L.4: DFO Request for Review Supplemental Report (with Clarification Points)

Annacis Island WWTP New Outfall System

**FISHERIES AND OCEANS CANADA
REQUEST FOR REVIEW SUPPLEMENTAL REPORT**

**ANNACIS ISLAND WASTEWATER TREATMENT PLANT
NEW OUTFALL - ANNIEVILLE CHANNEL, FRASER RIVER**

Attachment 8: River Bottom Relief Image

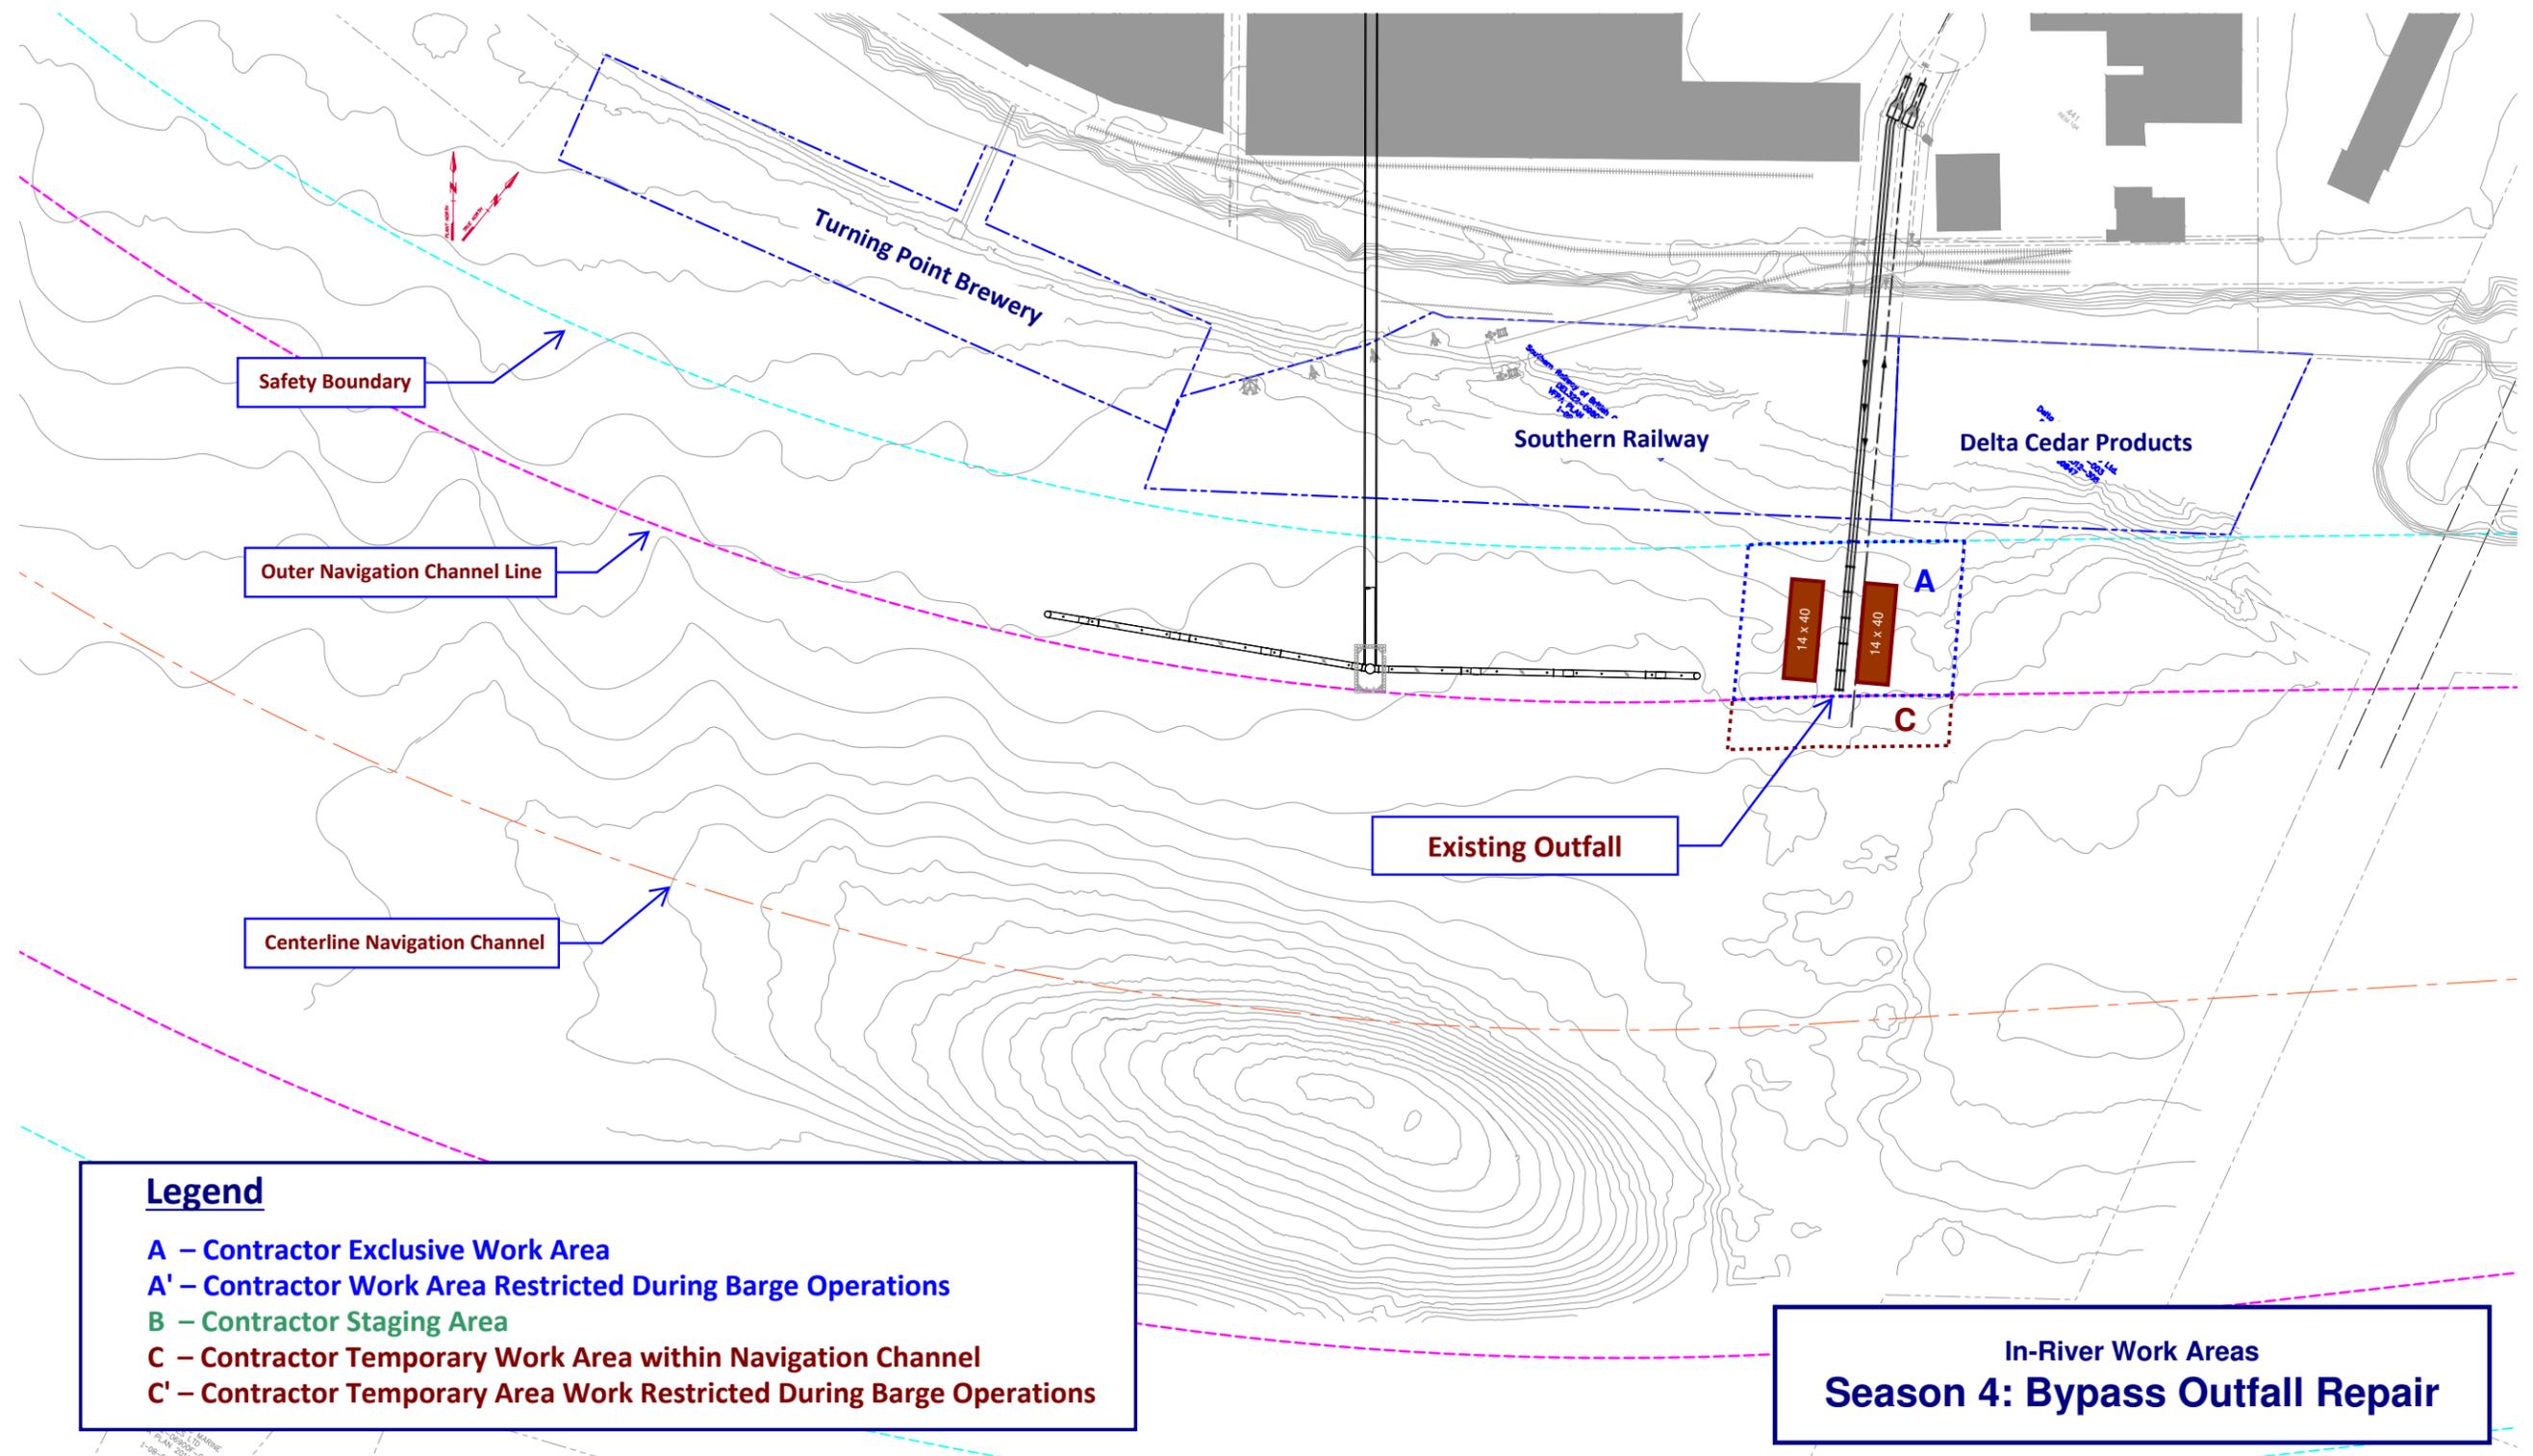
Geomorphological studies performed for the project indicate that sand deposition in this area occurs as low period “sand waves” up to about 1 m in height (see [Attachment 8](#)). Immediately upon completion of the outfall construction, the river bed will be left at the over-dredged limit used by VFPA when maintenance dredging (about 2 m below the minimum dredge channel depth). The maximum area of exposed armor rock at this point is on the order of 4,100 square metres as shown on Figure 2 in the Request for Review. However, the portion left below the navigation depth will quickly fill in with sand when left to the natural deposition environment. The natural sand waves in the area will re-establish themselves during the first freshet resulting in the armor rock being mostly covered by sand (see [Attachment 9](#)). The maximum area of exposed armor rock after the river bottom reverts to its natural deposition condition will be considerably less than the 1,100 square metres as shown on Figure 2 in the Request for Review.

2. Sediment transport along the channel bottom in this area are characterized as medium to coarse sands moving along the river bed in 'sand waves'. These sand waves are analogous to sand dunes which migrate laterally due to erosion on the windward side and deposition on the lee side.

3. On page 5, paragraph 1 of the November 15th Supplemental Report, where we state that "*the location of the outfall was selected to be in an area where sand accumulation is limited by seasonal scouring and re-deposition of sand*", the intent was to distinguish the outfall location from the inside of the Mungo Bend immediately downstream of the planned outfall location where the sand waves do not reach dynamic equilibrium. In this area, the sand waves continue to grow in height, building up to several metres over a period of one to two years. The port authority is required to regularly perform maintenance dredging to maintain the navigation channel depth. Upstream, where the outfall is planned, bathymetric soundings over the last 10 years indicate that river bed elevation is more stable and has fluctuated less than one metre from its average elevation. The shallow, short amplitude sand waves moving through this area reach a dynamic equilibrium and do not continue to build up over time.

Attachment 9: Evolution of Final Constructed Condition

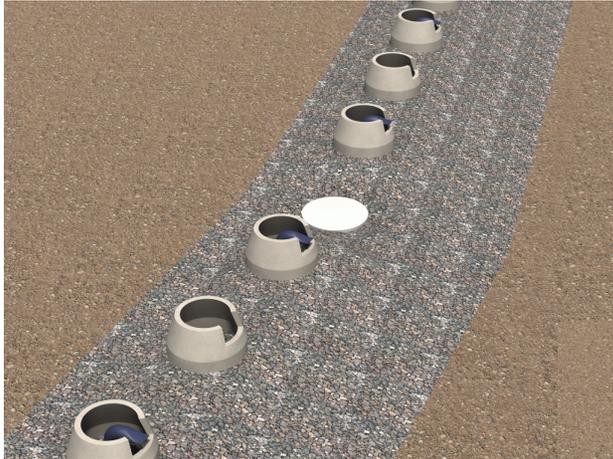
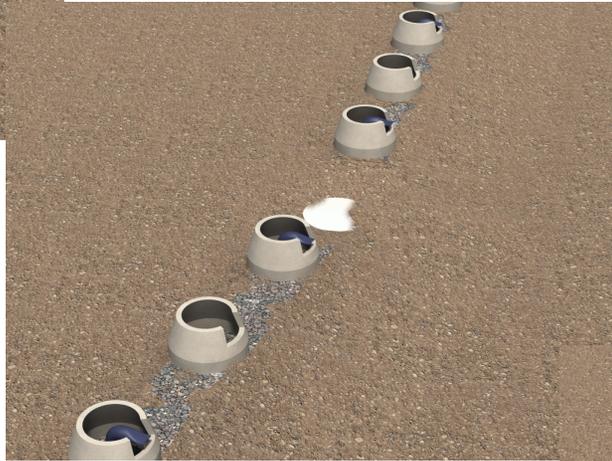
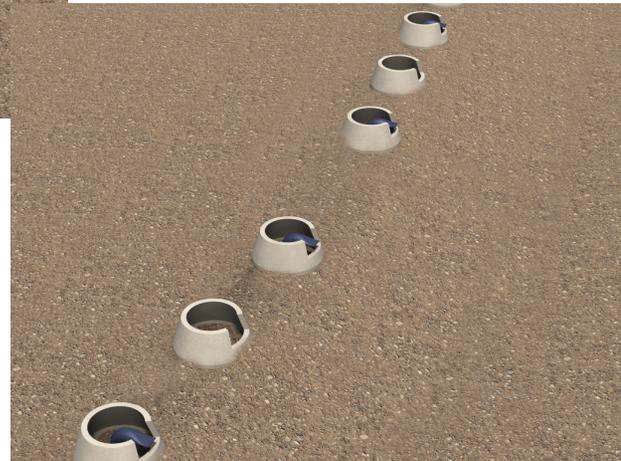
7. We anticipate that sediment migration will soon revert to its typical condition of scouring and re-deposition in the form of sand waves up to one metre in height migrating in dynamic equilibrium along the future average river bed elevation. This condition will be established by the first spring following construction, as the greatest amount of sand deposition and migration occurs during the freshet. At the upstream end of the diffuser, it is likely that the armor rock would be periodically exposed as the sand waves traverse the area. The armor rock is less likely to be exposed as sand waves migrate along the river bed at the downstream end.

8. There is no practical way to make an accurate prediction of the amount of armor rock that will be exposed for an extended period; however, it will be considerably less than the total area of armor rock (1,100 m²) at the navigation channel bottom elevation.
